**CITY OF TWIN OAKS
PLANNING AND ZONING COMMISSION MEETING
BOARD CHAMBERS, TWIN OAKS CITY HALL
1381 BIG BEND ROAD
TUESDAY, JANUARY 25, 2022 6:30 P.M.**

“C” COMMERCIAL DISTRICT APPLICATION FOR PRELIMINARY DEVELOPMENT PLAN

First round comment response letter

Twin Oaks, Missouri
1100 Meramec Station Road – BFA 3497-0

CONCEPT EXTERIOR ELEVATIONS
Project Number: 2021.019
Date: 11.04.21

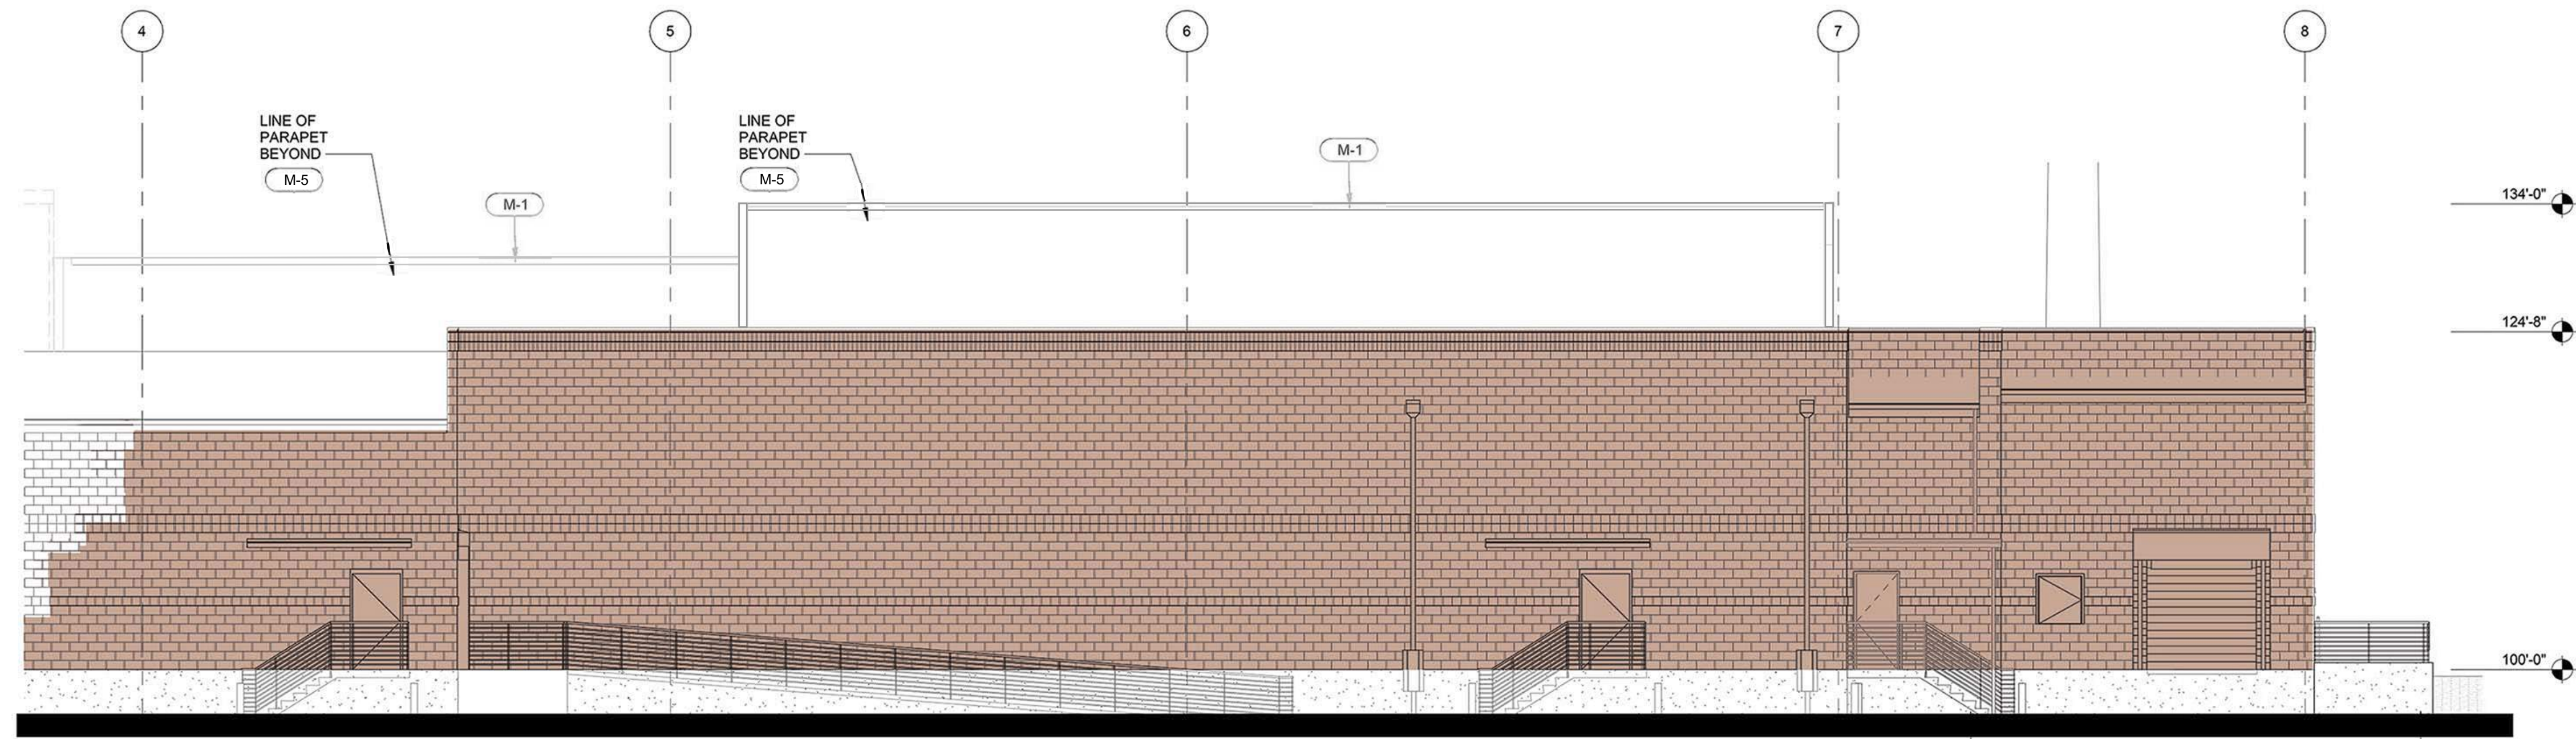
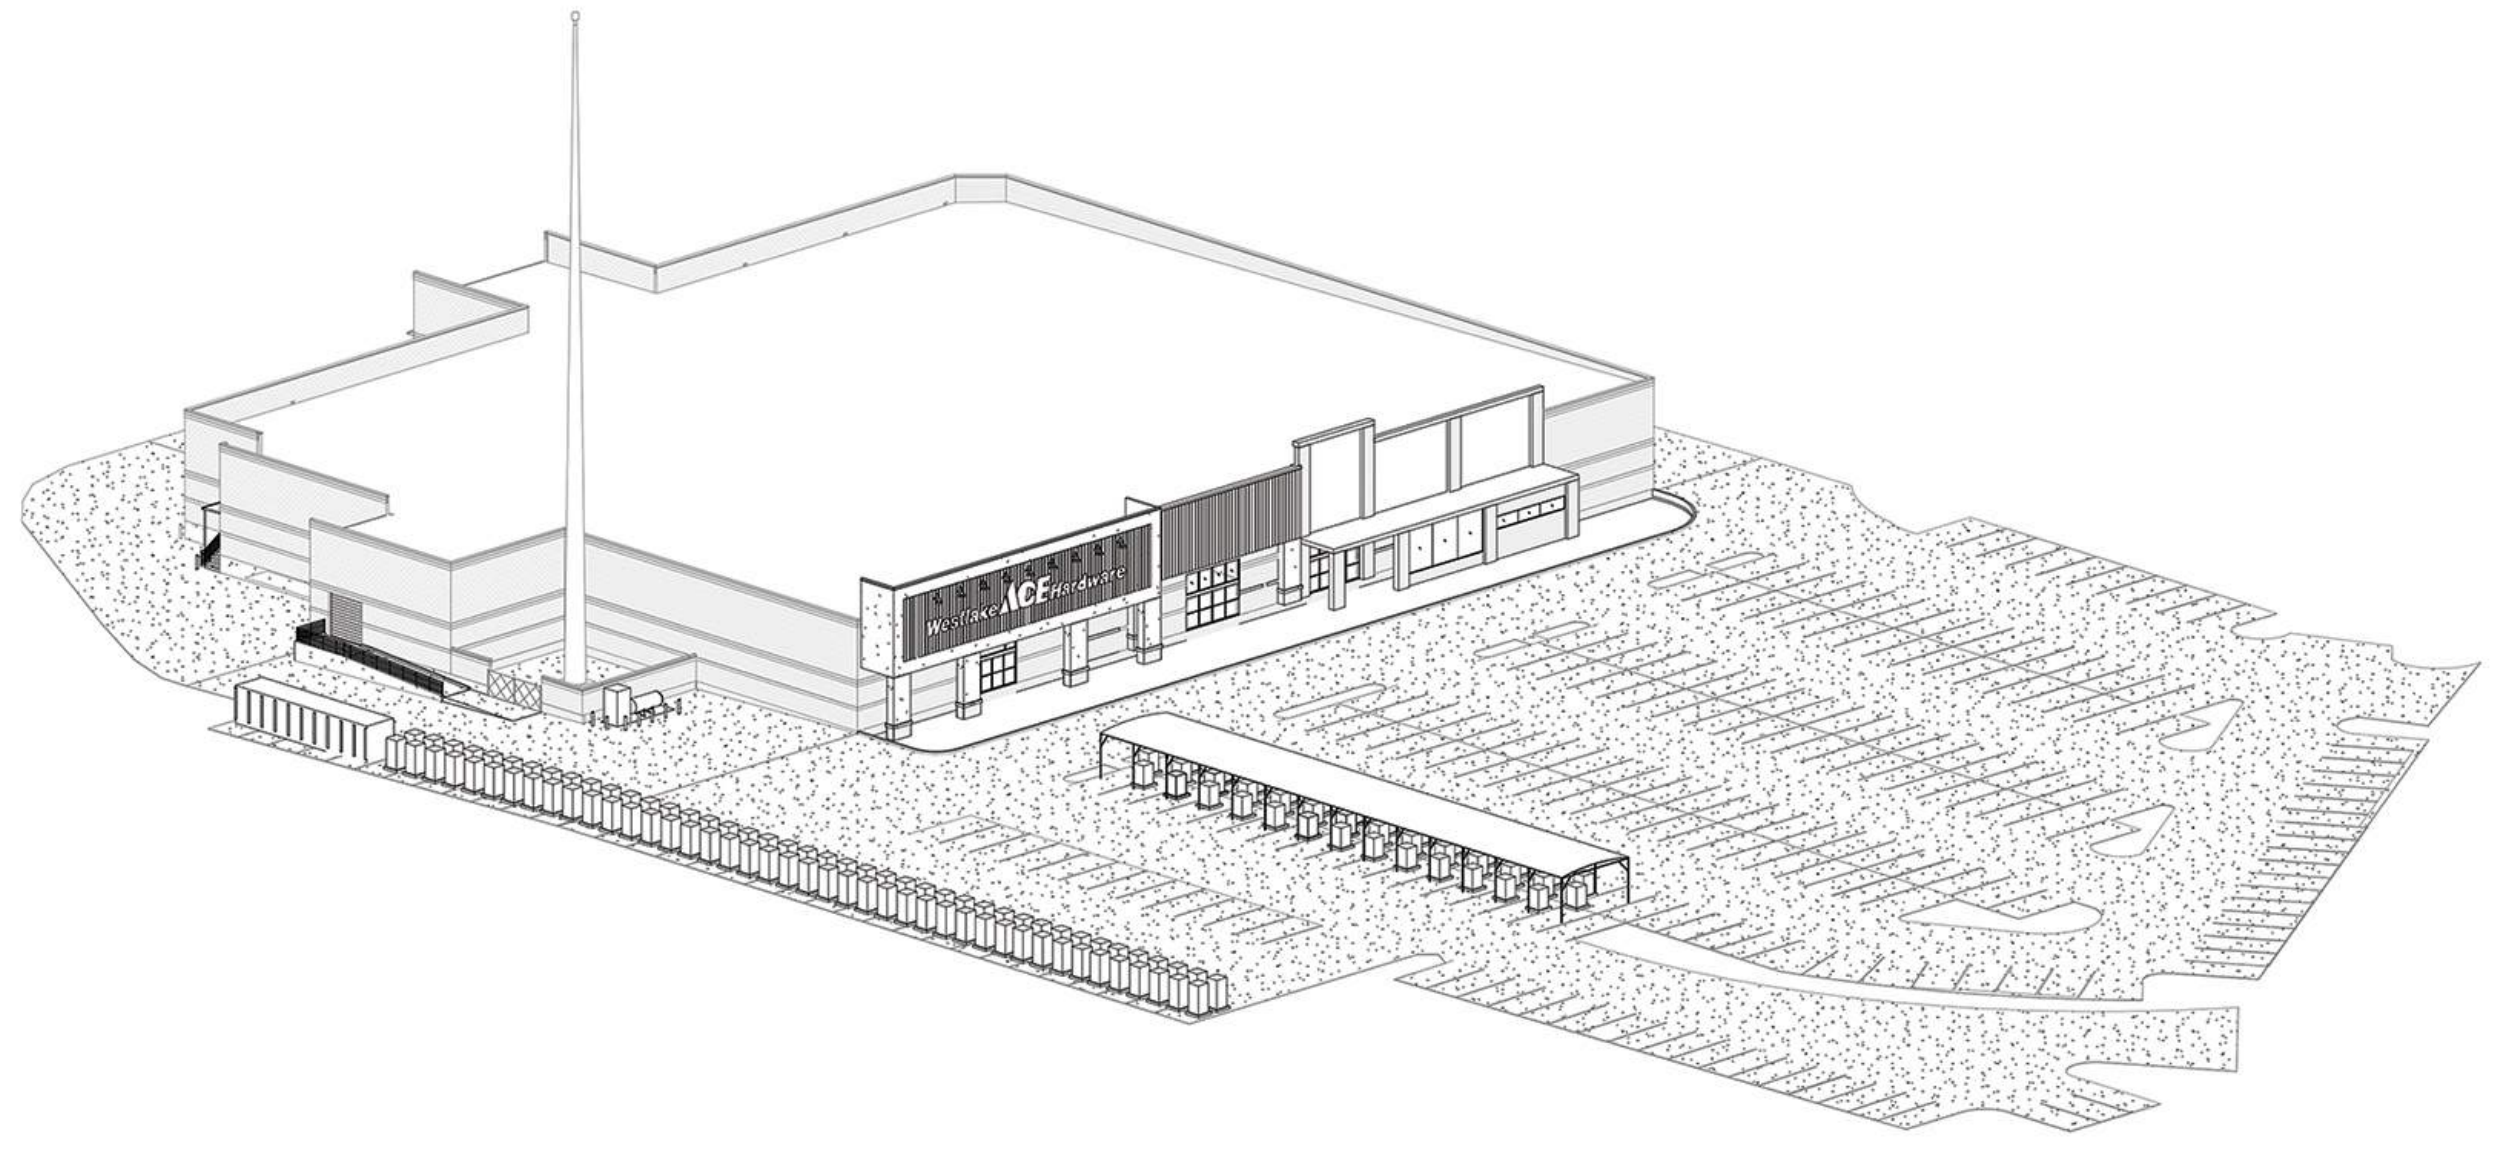
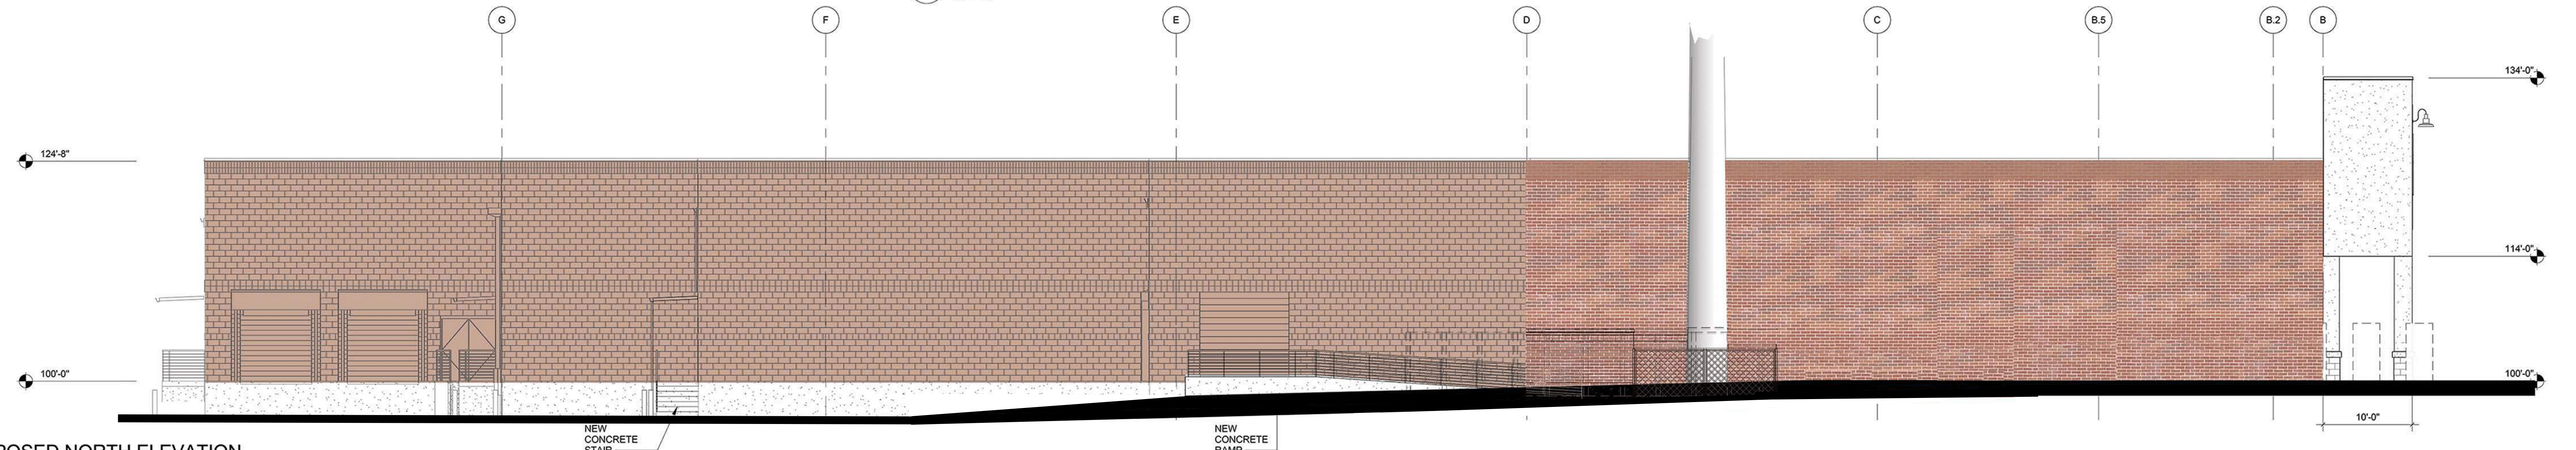
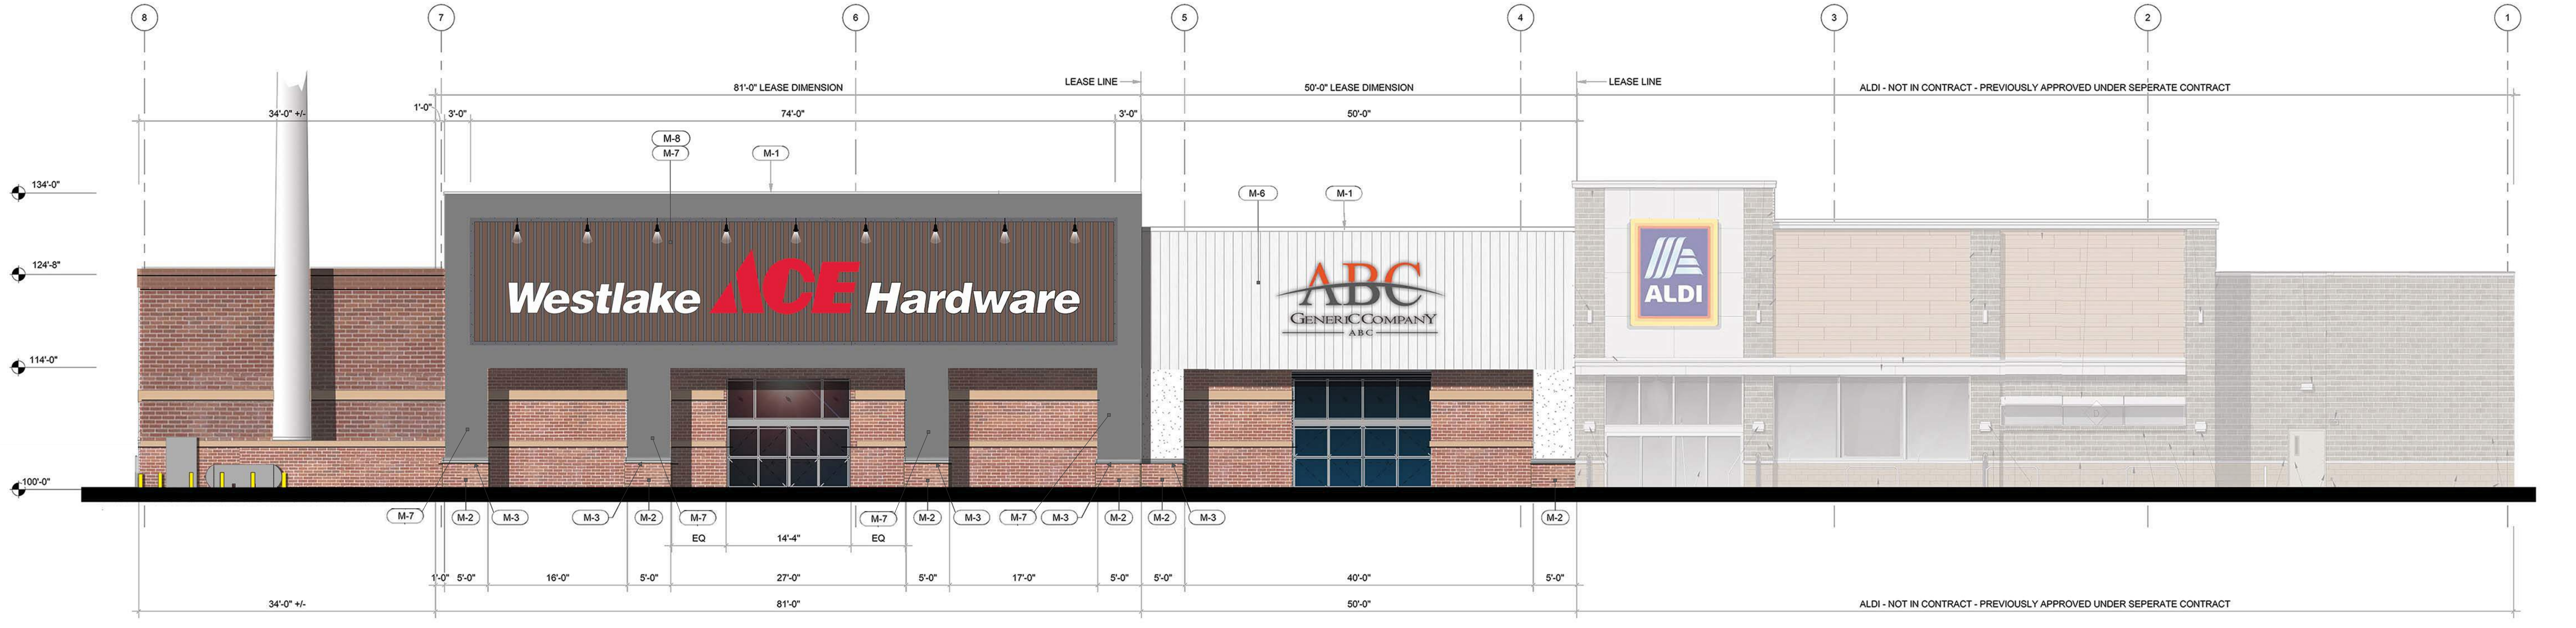
1. M-2 Concrete Masonry Veneer is not acceptable per Appendix A A5. Please revise and utilize an acceptable material per Appendix A A5.
 - M-2 has been changed to brick.
2. M-3 Cast Stone Sill is not acceptable per Appendix A A6. Please revise and utilize an acceptable material per Appendix A A5.
 - M-3 is stone.
3. M-5 TPO Membrane Roofing is not acceptable per Appendix A A5. Please revise and utilize an acceptable material per Appendix A A5.
 - TPO membrane is an existing roofing material and is not visible to the public.
4. The current design does not provide screening to the proposed dumpster/trash compactor. Please reevaluate the design and screen trash container with evergreen hedges, walls, screens planted with evergreen vines per Appendix A F.4.
 - Dumpster Screen wall layout 1 on sheet CTEP has been added accordingly.

PHOTOMETRIC PLAN
1/32" = 1'-0"

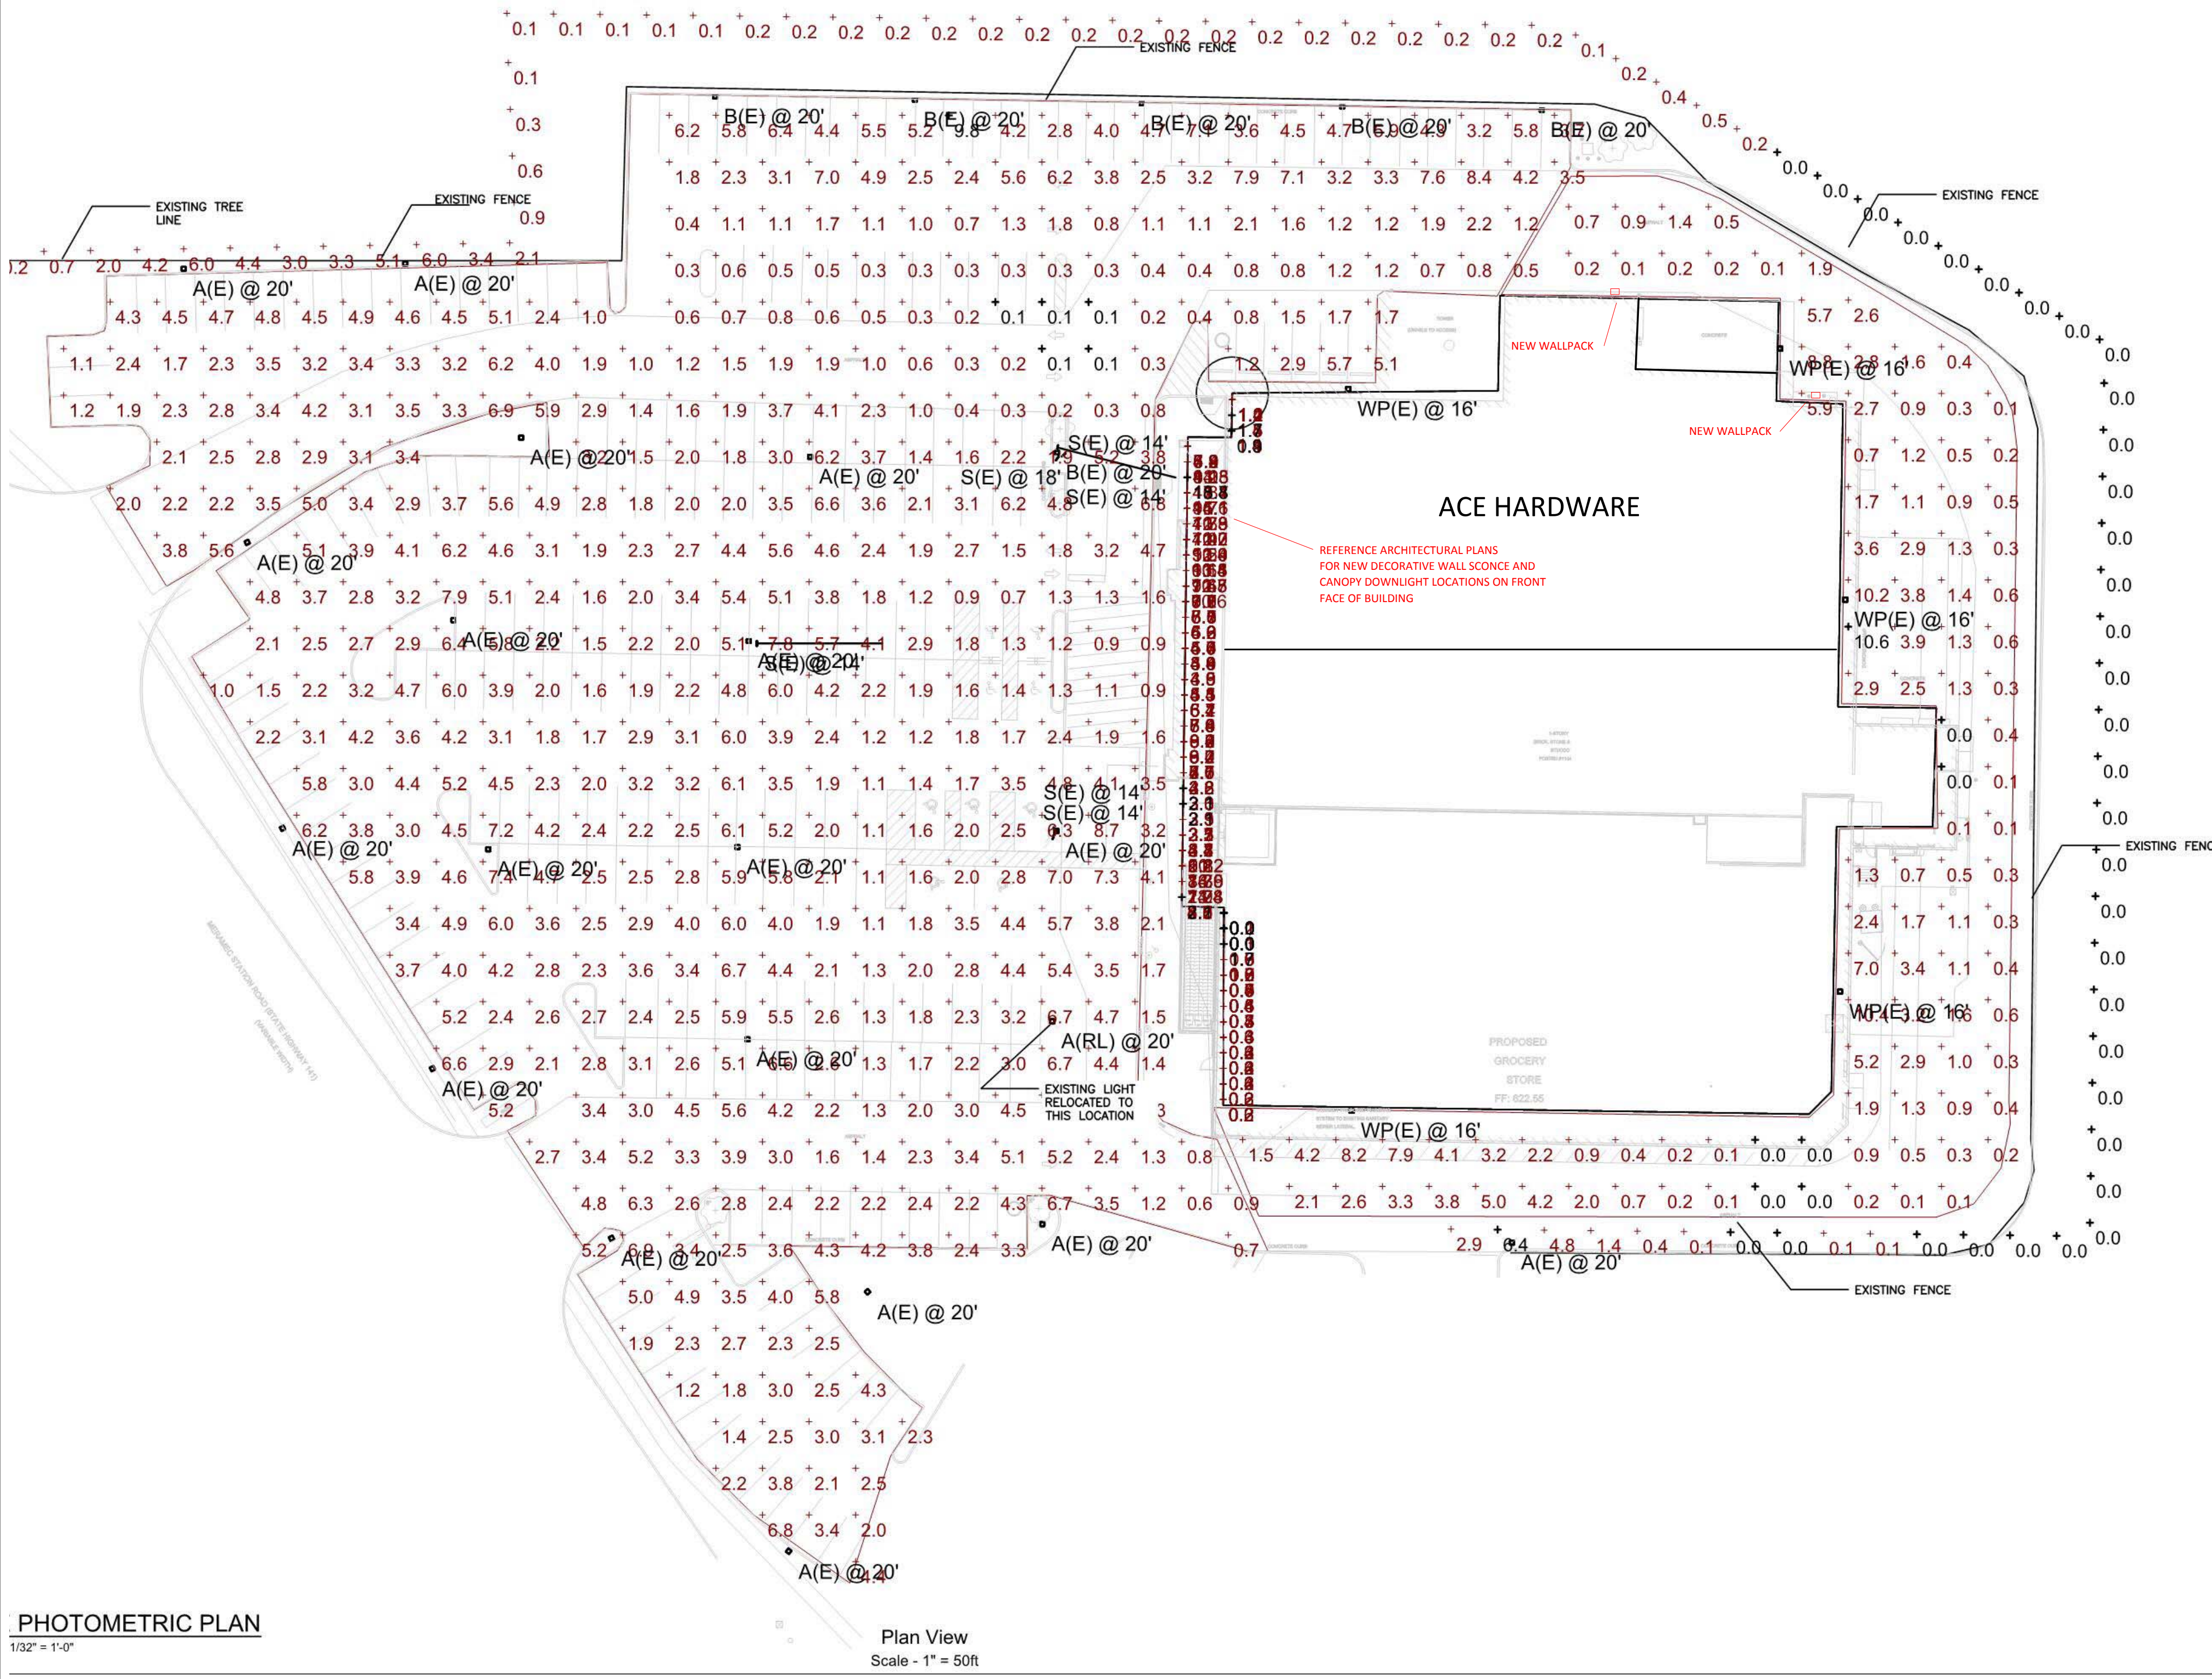
13. Please provide a photometric plan to ensure the proposed light follows light cast regulations per Section 400.330 A.5.
 - Photometric has been added accordingly.
